# Staff Report

Re: **New Construction -PLNHLC2017-00555**

## NEW CONSTRUCTION – MIXED USE

**PROPERTY ADDRESS:** 563 & 567 East 600 South

EXTERIOR ELEVATIONS

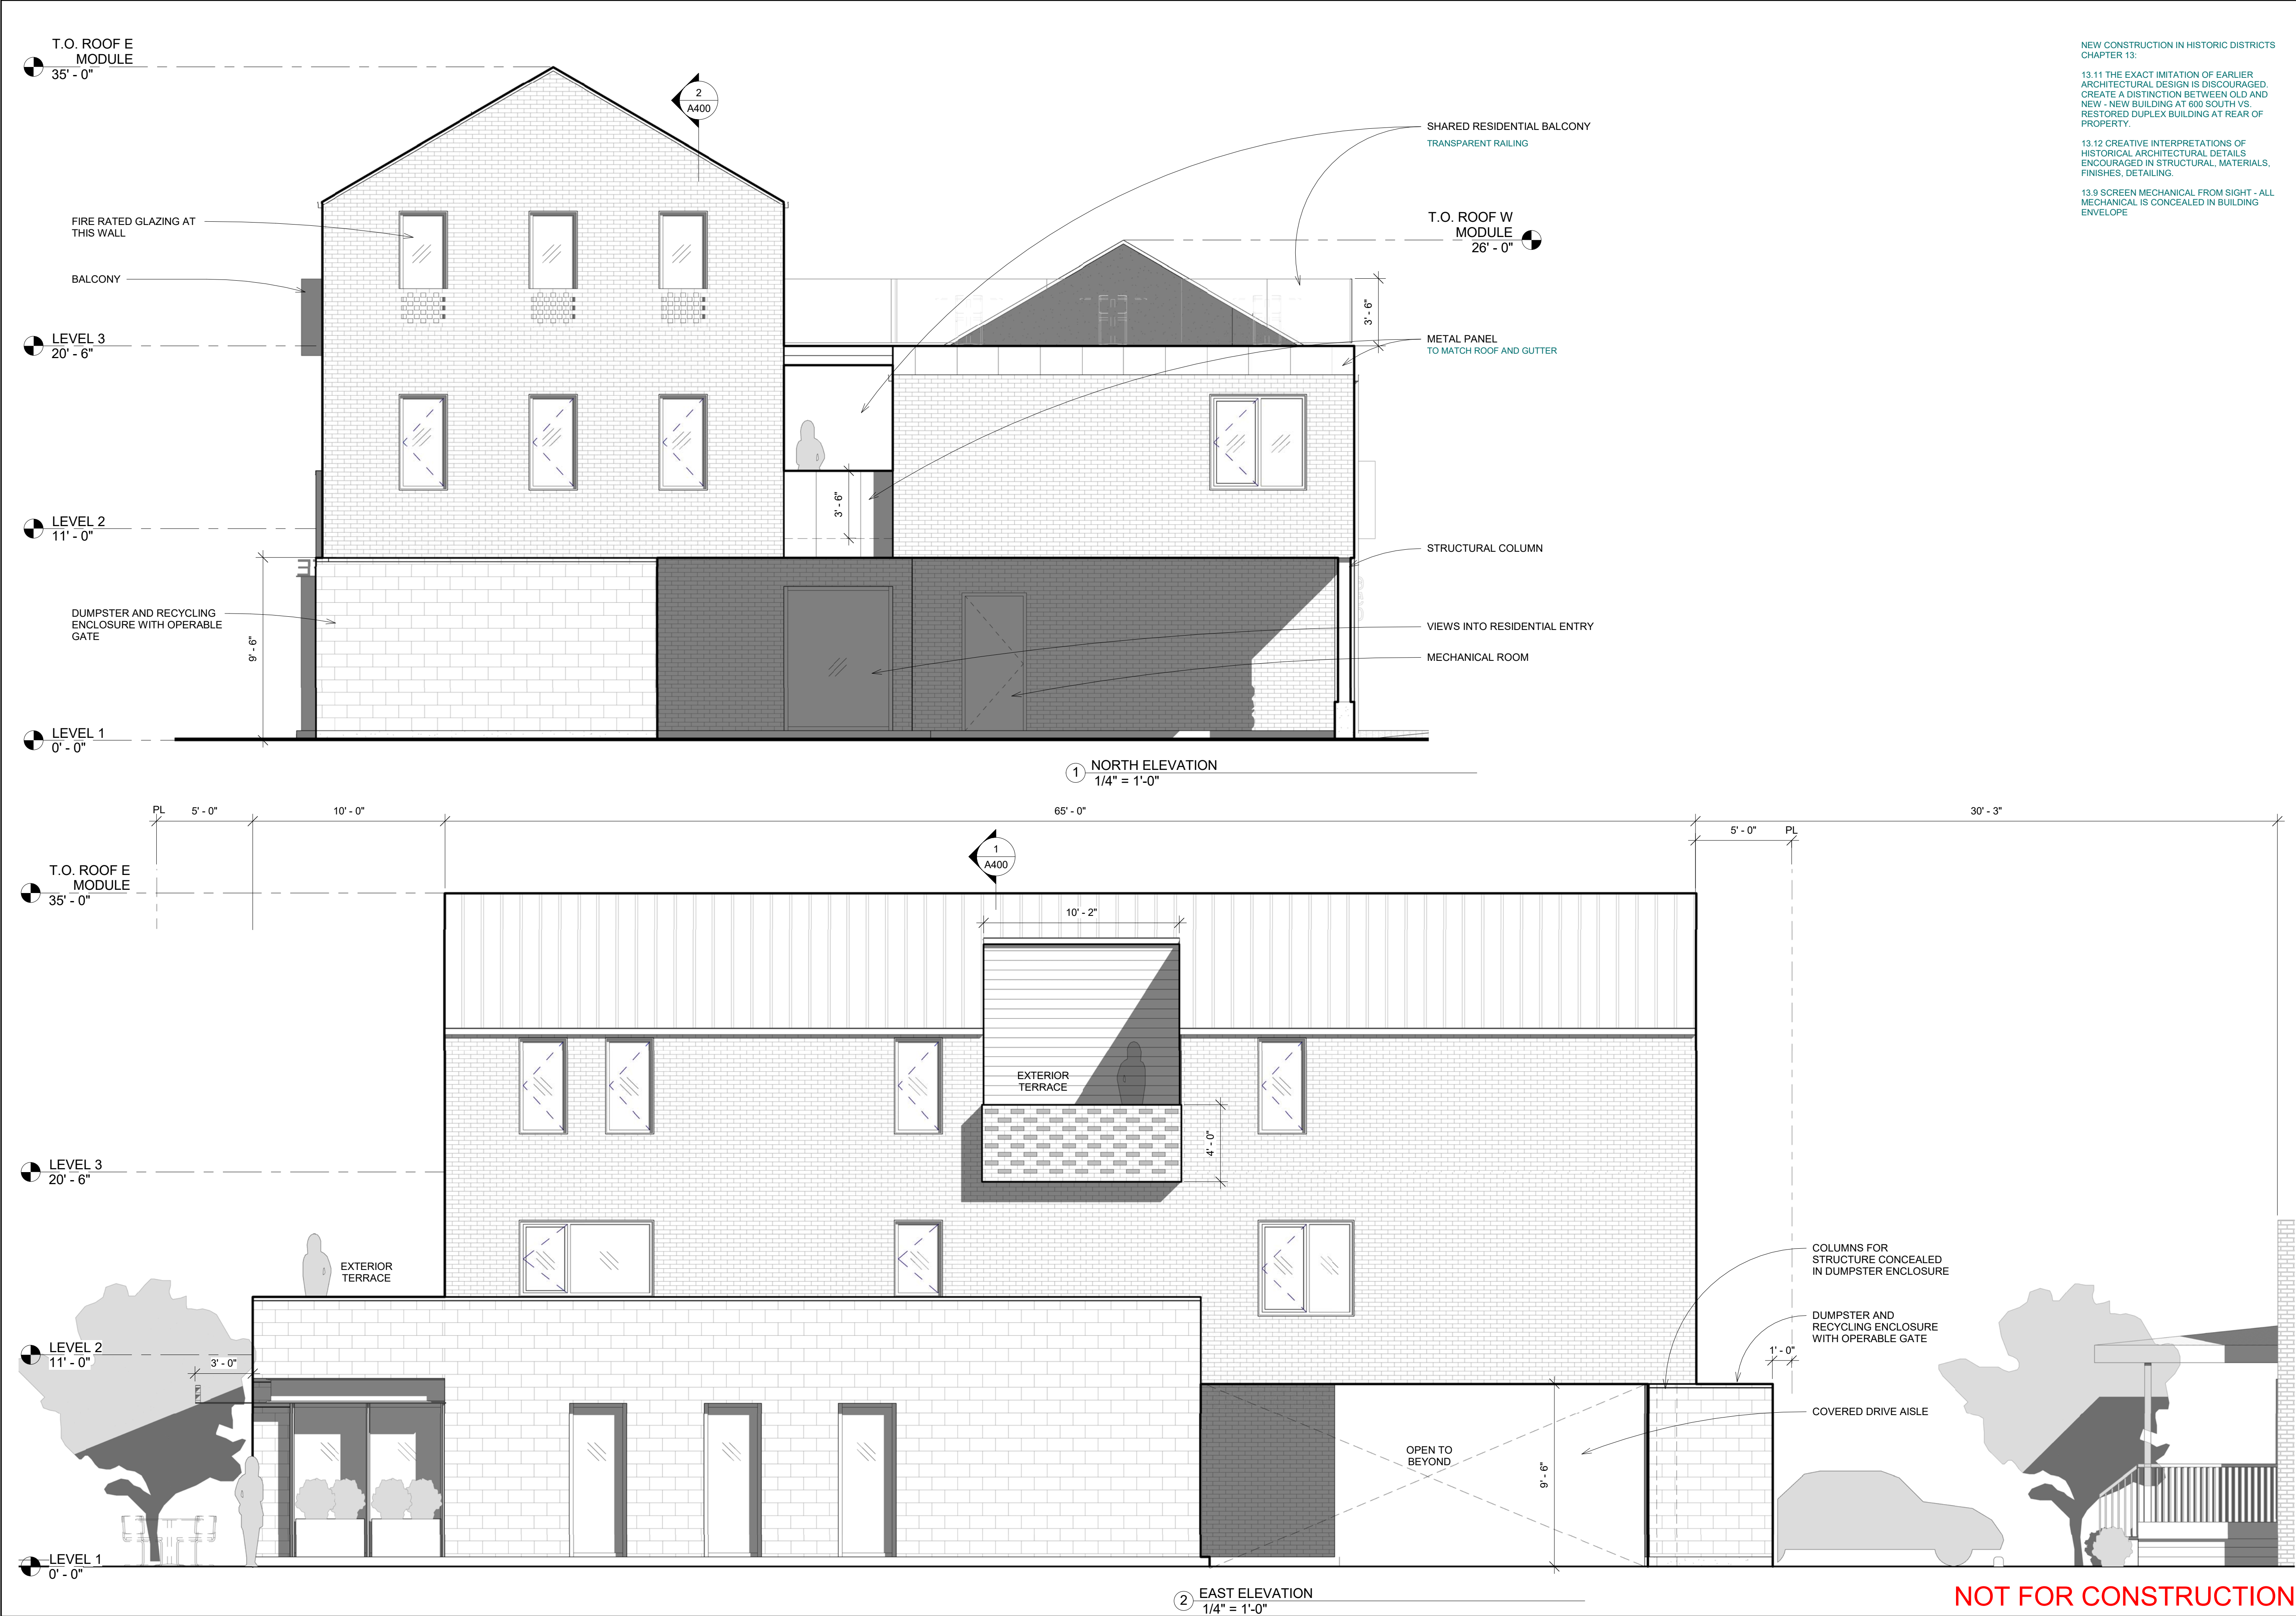
The design guidelines indicate that the ratio of wall to window should reflect that found across the established character created by the historic structures in the district. The ground floor commercial area of the proposal is transparent and helps create an open human scale design. The narrative for the project describes the proposed windows as being vertical in nature with larger windows broke up with operable portions to emphasize an appropriate scale. The proposed building is primarily designed with horizontal proportions, and although the windows do help add vertical emphasis, the proposed design appears contrary to opening proportion of buildings in this historic context.

There is a large area of blank wall on the ground floor of the street facing residential building portion of the structure. The applicant did not provide floorplans but indicated this blank wall is shown as a backdrop and a delineation for the retail space that would be used as outdoor seating, but would not disturb the residential space beyond. The applicant has indicated there may be restrooms planned for behind that wall. Staff is of the opinion this large blank area is not consistent with the fenestration pattern of primary facades along the streetscape.

1. Staff recommends modifications to the window design in regards to proportions, fenestration, and solid to void ratio. Window modifications and any other design details identified by the Commission shall be delegated to Planning Staff.
